**R66 Engine Electrical Harness & N1 Sensor Upgrade Kit Instructions**

*(To comply with R66 Service Letter SL-46)*

*Applicable to helicopter S/N 0004 thru 1369. Replaces all previous F049-XXX engine harness assemblies with new F049-018 engine harness assembly, and replaces Rolls Royce P/N RR30000206 N1 sensor with RHC P/N F049-019 N1 sensor electrical harness assembly. Helicopter S/N 0274 & prior may require KI-190 for engine oil pressure warning light ground, which can be installed concurrently.*

**FIGURE 1 F049 engine electrical harness assembly**  
(Remove existing harness & bracket from engine)

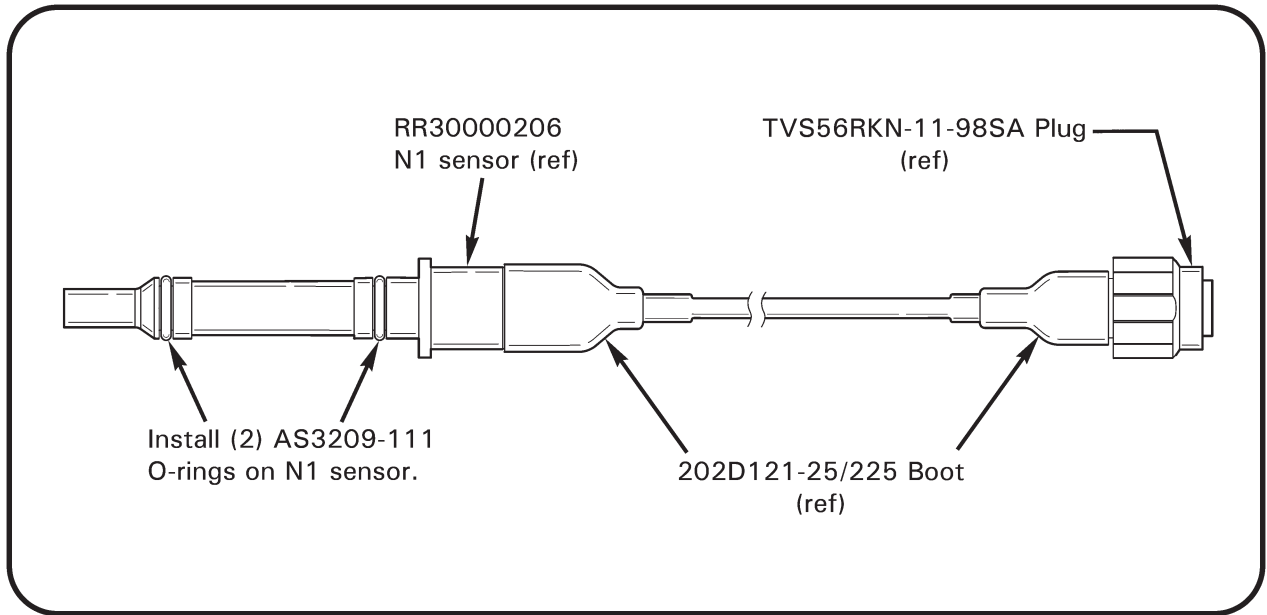
3. Remove F049 harness per MM § 71-11, step 4. Retain installation hardware, except (1) MS9592-050 bracket as indicated in Figure 1, and (1) MS21919WCH4 clamp at bracket on engine lube oil filter assembly (see Figure 3, Detail A).
4. Remove N1 speed pick up sensor per Rolls-Royce Operation and Maintenance Manual (OMM) Task 77-11-10-000-801. Return to RHC with a completed RSF 205 Component Return/Authorization, available at <https://robinsonheli.com/> >Customer Support >Forms.

8. Continue F049-018 electrical harness assembly installation per MM § 71-12, step 15.h. thru k..
9. If F173-2 shield is not installed:
  - a. Refer to Figure 1. Remove & retain MS27039C1-06 & MS27039C1-07 screw and D210-3 nuts.

- b. Using retained hardware, install F173-2 shield as shown. Standard torque screws per MM § 20-32.
10. Connect F049-018 harness assembly to F059 (or F859) cabin harness assembly. Verify security. Secure harnesses using appropriately-sized ty-raps, as required. Cinch ty-rap until snug without over-tightening, and trim tip flush with head.

**FIGURE 2 F049-019 N1 sensor electrical harness assembly**  
(O-ring installation)

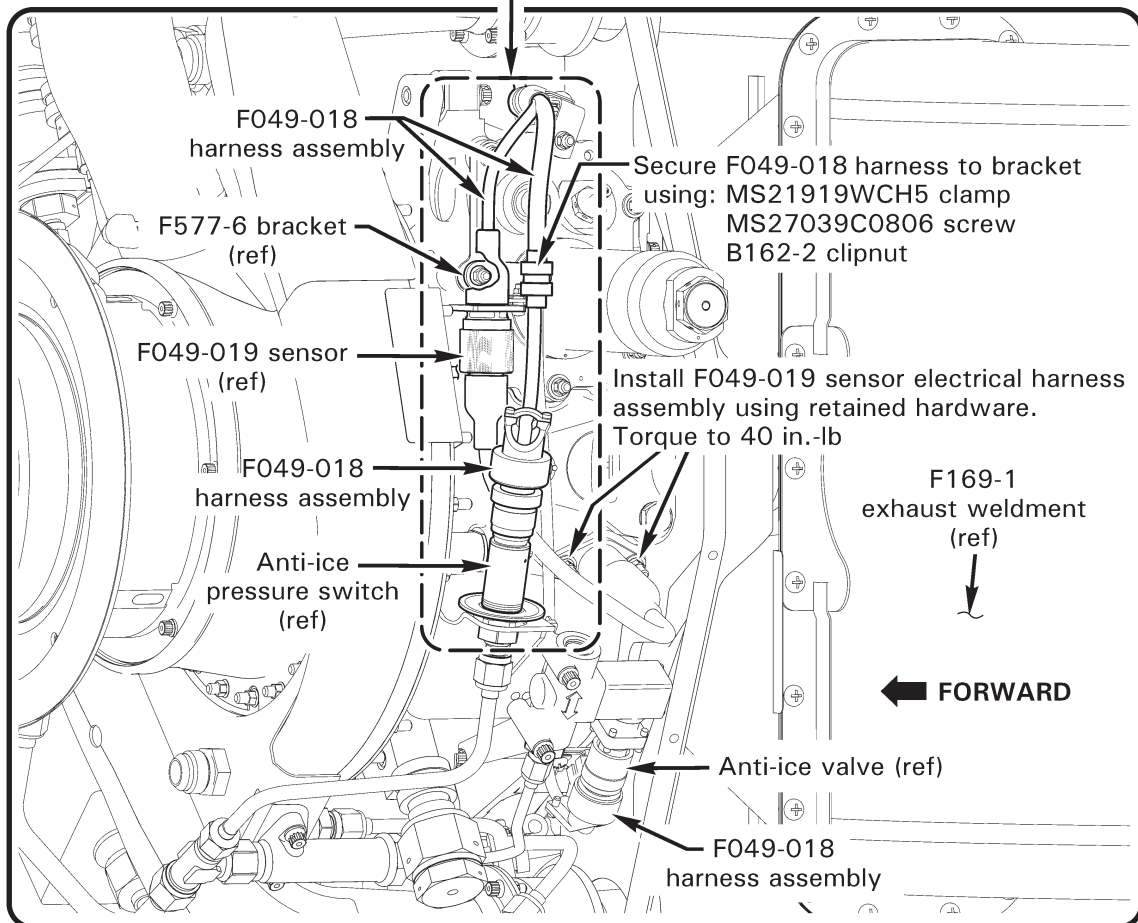
5. Refer to Figure 2. Lubricate (2)AS3209-111 o-rings using A257-23 turbine oil. Install o-rings on F049-019 N1 sensor electrical harness assembly as shown. Apply high temperature anti-seize to the threads of N1 installation studs. Install N1 sensor to engine using retained hardware; torque nuts to 40 in-lb.

**FIGURE 3 F049-018 & F049-019 harness assembly installation**  
(Detail A rotated for clarity)

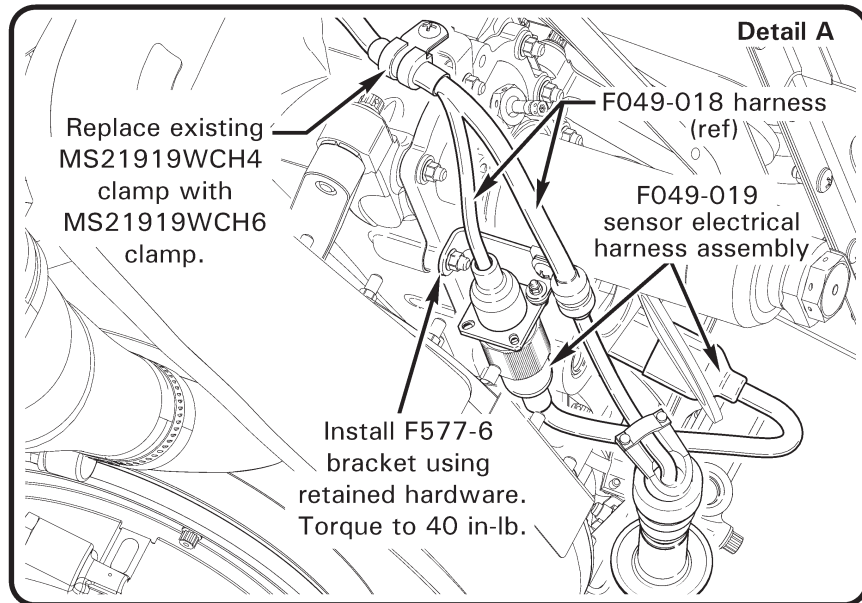
7. Refer to Figure 3 and continue F049-018 electrical harness assembly installation as follows:
  - a. Install (supplied) MS21919WCH6 clamp around harness assembly and install on MS9592-050 (engine-supplied) bracket on engine lube oil filter assembly (Detail A).

- b. Install F577-6 bracket to engine lube oil filter assembly (where MS9592-050 bracket was removed in step 3), using retained hardware. Torque to 40 in-lb. Connect F049-019 N1 sensor electrical harness assembly plug to F049-018 harness assembly receptacle at F577-6 bracket.

- c. Connect F049-018 harness plugs to anti-ice valve assembly solenoid and anti-ice pressure switch assembly. Install (supplied) MS21919WCH5 clamp around harness assembly and install to F577-6 bracket using retained hardware.
